# **Safety Bulletin**

## **TIVOLI MFG. LTD.**

Bulletin No: ORSA002A

**Purpose: Inspection of top center hub area.**

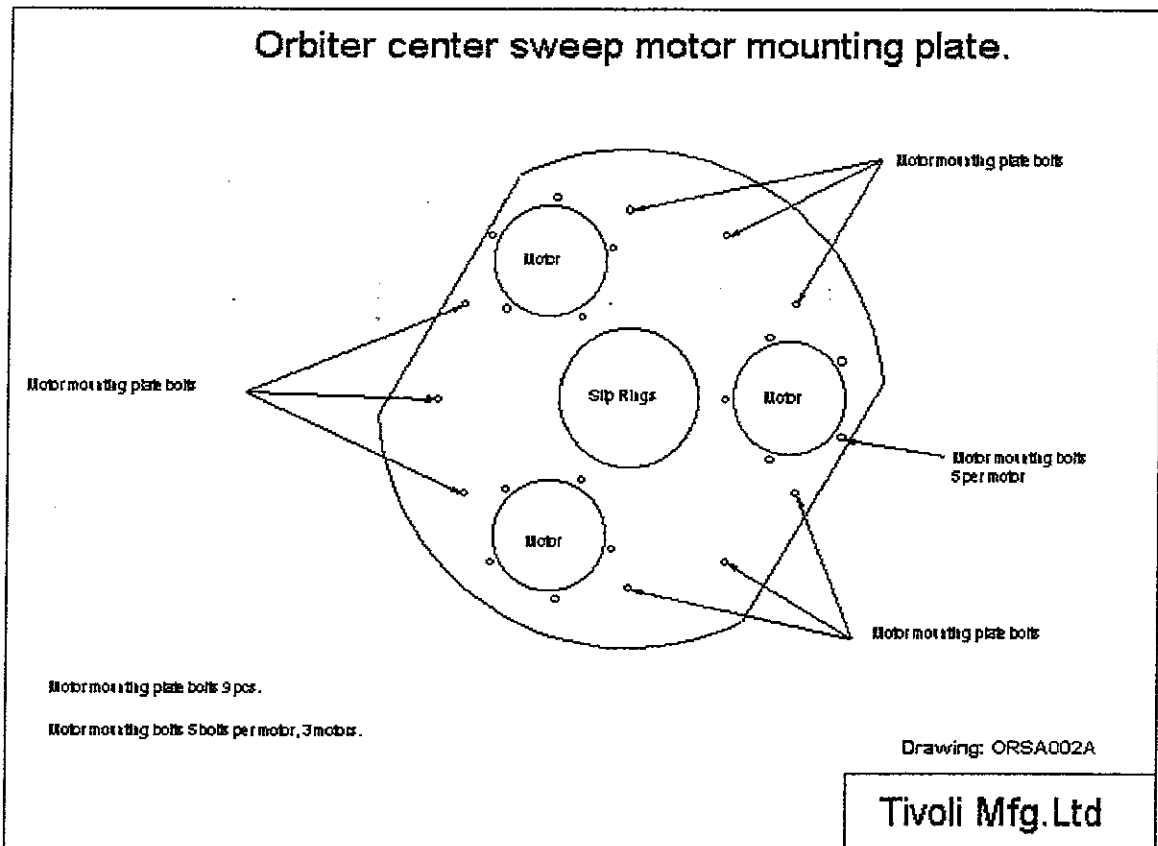
- **Replace all nine (9) bolts securing motors mounting plate to hub.**
  - 9 – 12mm x 45mm bolts spread equal distance around outside parameter of plate. See Attached drawing ORSA002A (See Attached)

**Bolt Specification for three motors and motor mounting plate.**

**Bolt:** Hex head, 12 mm x 45 mm x 1.75, grade 8.8, partial thread, black finish. Ref: DIN 931 / ISO4014

**Washers:** 12 mm, flat hardened washers, 13 mm ID, 24 mm OD, 3 mm thick. C45. Ref: DIN 6916

**Tightening Torque Requirements:** Tighten bolts to 65 ft-lbs.
